Response to Requests for Additional Information for the Review of the ARCADIA[®] Reactor Analysis System for PWRs Methodology Description and Benchmarking Results Topical Report

ANP-10297Q1NP
Revision 0

AREVA NP Inc.

Figure 7.3-2: Heavy Reflector Geometry

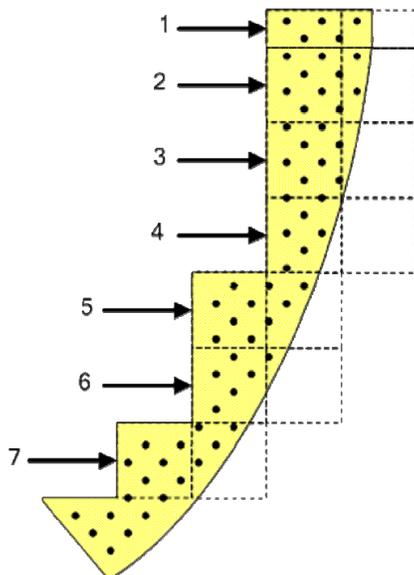
RAI 22 For “heavy reflectors”, (reflectors comprised of a thick steel shroud and low moderation inside the core barrel), the water scattering cross sections are calibrated with factors “deduced from the comparison of the 2D power density distribution calculated by ARTEMIS with the corresponding reference MCNP result”. The methodology used to “deduce” these factors should be documented and some justification should be made as to the application of the modified scattering cross section to other plant/fuel types. A quantification of the magnitude of the calibration should also be provided. [Page 7-4]

The 1D spectral geometries with reflective boundary conditions used for deriving the cross sections for the radial reflector neglect transverse leakage (2D) effects. For the heavy reflector this leads to discrepancies between ARTEMIS and MCNP reactor calculations when using non-adapted reflector cross sections.

An iterative procedure, a variant of the simulated annealing algorithm, was developed for the purpose of deriving adaptation factors for the heavy reflector cross sections. The procedure adapts the microscopic slowing-down cross section of H₂O until spread and standard deviation of the differences of the normalized core wide power density distribution of ARTEMIS and the fission rate distribution of MCNP are minimized. In ARTEMIS the normalized power density and fission rate distribution is consistent.

Two types of adaptation factors were found to be sufficient for avoiding heavy reflector induced in/out or azimuthal trends, one for non in-side (edge) and one for re-entrant (corner) reflector nodes. The classification of the heavy reflector nodes is (see Figure 7.3-2 of the Topical Report):

The resulting adaptation factors are 3.02 for the edge reflector nodes and 4.01 for the corner reflector nodes.

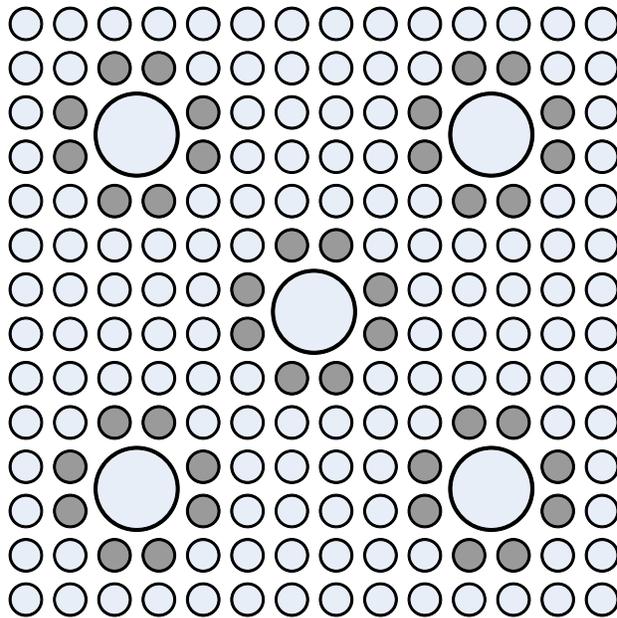
RAI 24 Figures 7.3-4 and 7.3-5 look like full core but the documentation states that MCNP was run with octant symmetry. Why are full core results provided?
[Page 7-5]

The represented cores are octant symmetric. Nevertheless, the ARTEMIS Calculations were performed in full core geometry. For direct application of existing scripts the MCNP results were unfolded to full core geometry.

Figure 28-G1-1: Plant G1 Cycle 26 Critical Boron Concentration vs. Burnup

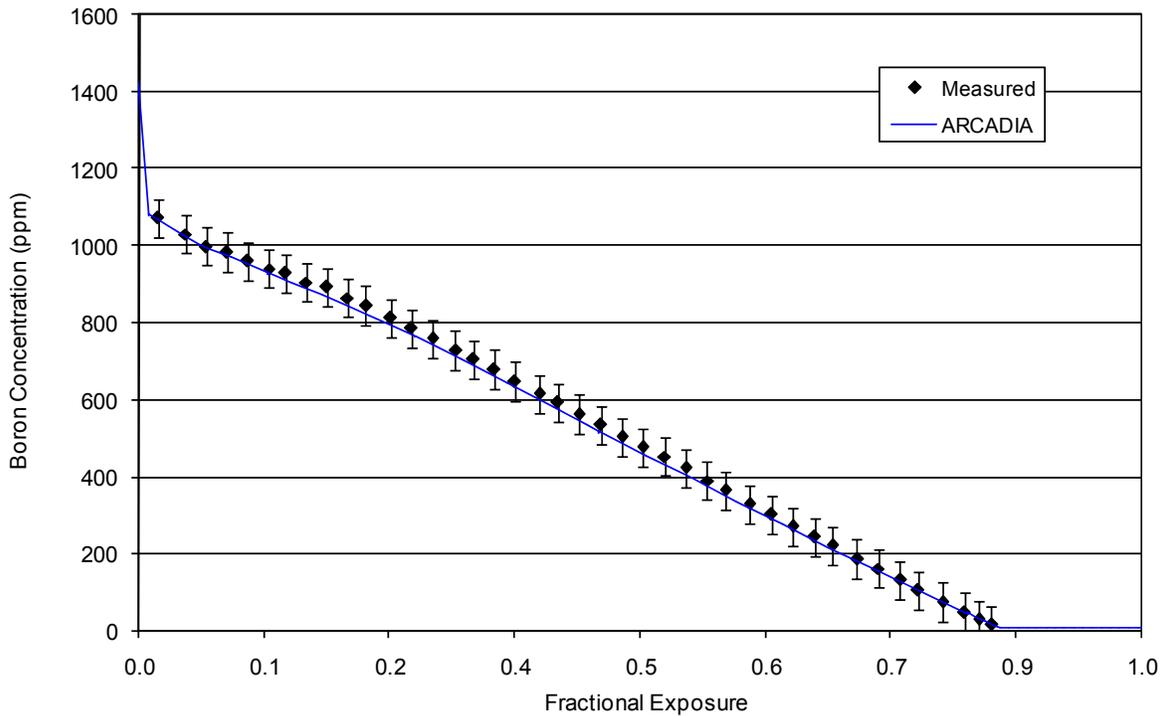
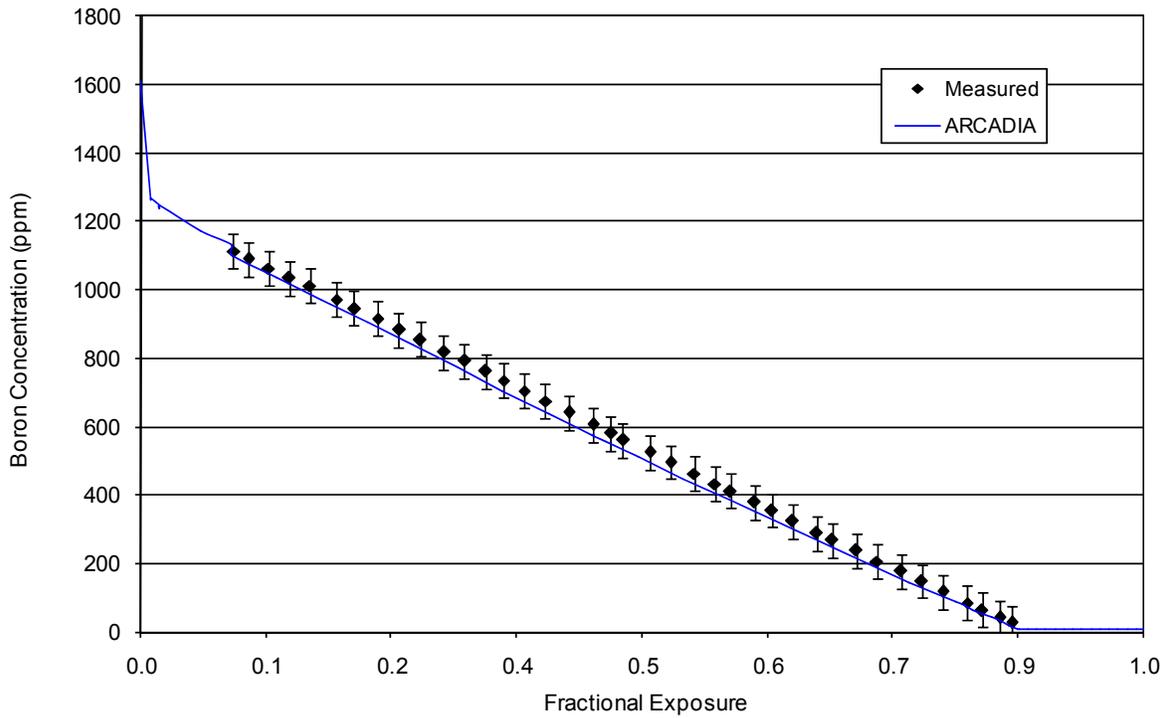
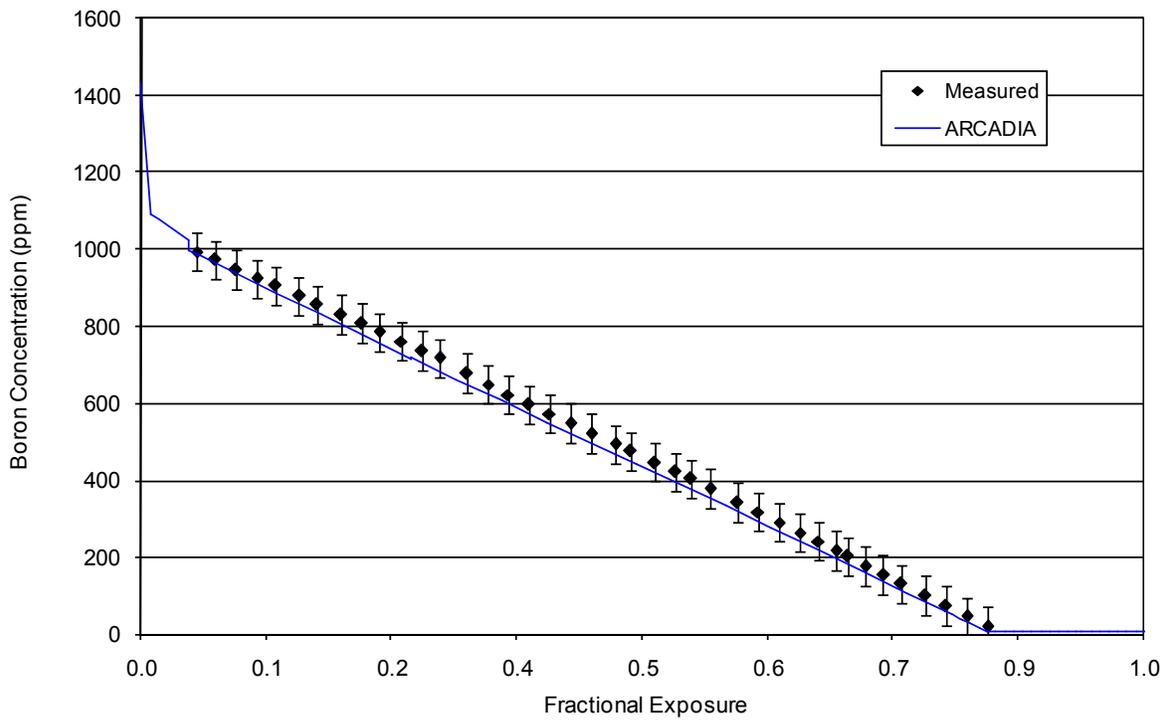
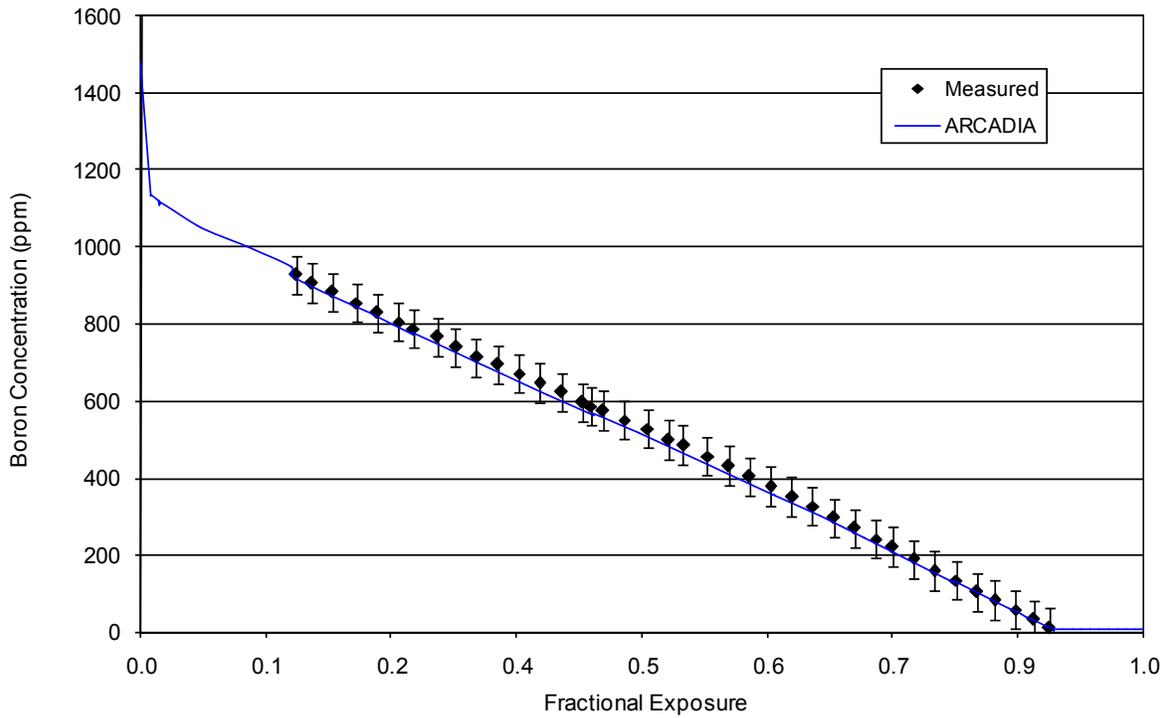
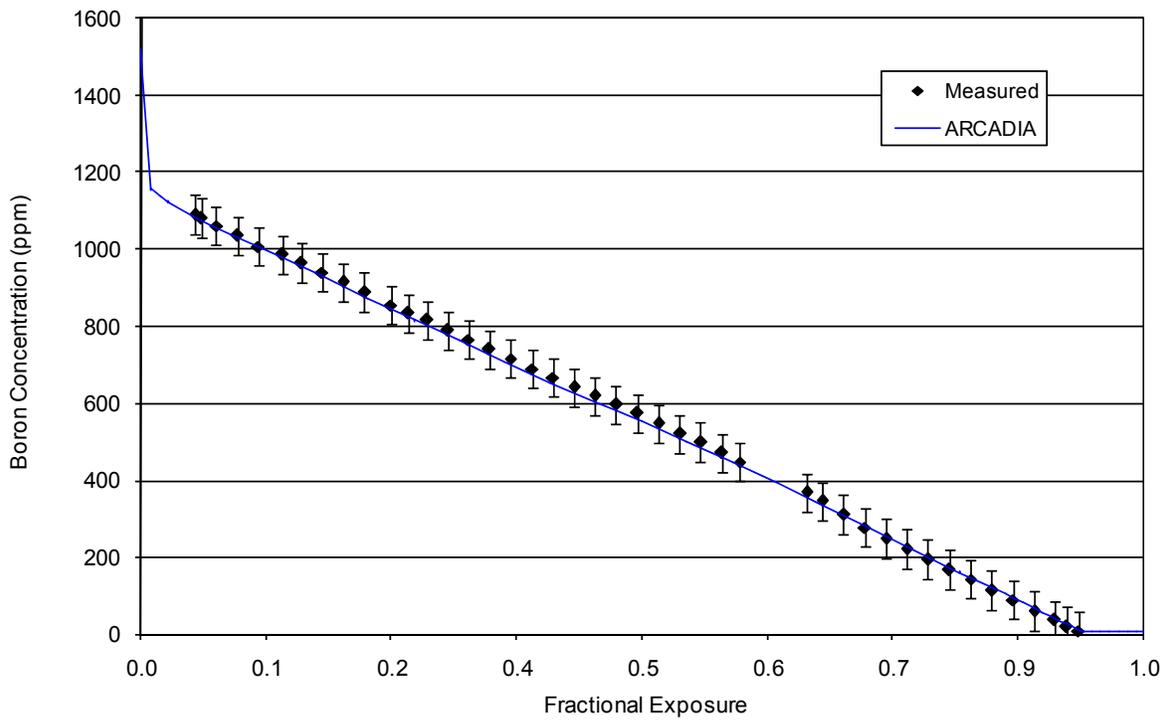
RAI 28 Plant G1 Cycle's 27 and 28 had a BOC B10 abundance of 19.2%. Also, Cycle's 29 and 30 used enriched B10 at about 30%. The report states that the Cycle 26 HZP boron measurement "may be suspect because of the B10 isotopic abundance was not measured". However, there are no unexpected comparisons at BOC HFP, which indicates that no additional B10 correction should be necessary at HZP. The report does not clearly describe which boron measurements are adjusted for B-10 content, and which are not. B10 corrections, both at HZP and HFP (i.e. B-10 depletion, if included) should be applied consistently for all cycles and should be clearly documented. [Page 10-31,1035]

Erroneously the critical boron adjustment in Table G1 10.3.4-1 and in Figure G1 10.4.4-1 of the Topical Report for Cycle 26 was applied to the calculated values to make them relative to the measured B-10 abundance instead of using the assumed measured B-10 abundance to adjust the measured critical boron concentrations such that they are relative to concentrations with natural boron. The values have been updated and are presented in Table 28-G1-1 and Figure 28-G1-1 (see below).

Moreover, in the Tables and Figures of Appendices G1 and G2 an inconsistency in the results has been corrected. The B-10 abundance of natural boron was assumed to be 19.74 a/o when adjusting the measured values, whereas ARTEMIS uses the value 19.9 a/o. To compare boron concentrations directly it is necessary that the adjusted measured boron concentrations correspond to the ARTEMIS B-10 abundance, so in the following tables and figures the measured boron concentrations have been adjusted to correspond to a B-10 abundance of 19.9 a/o.

These corrections have been applied and are shown in Table 28-G1-1, Table 28-G2-1, Figures 28-G1-1 through 28-G1-5 and Figures 28-G2-1 through 28-G2-5.
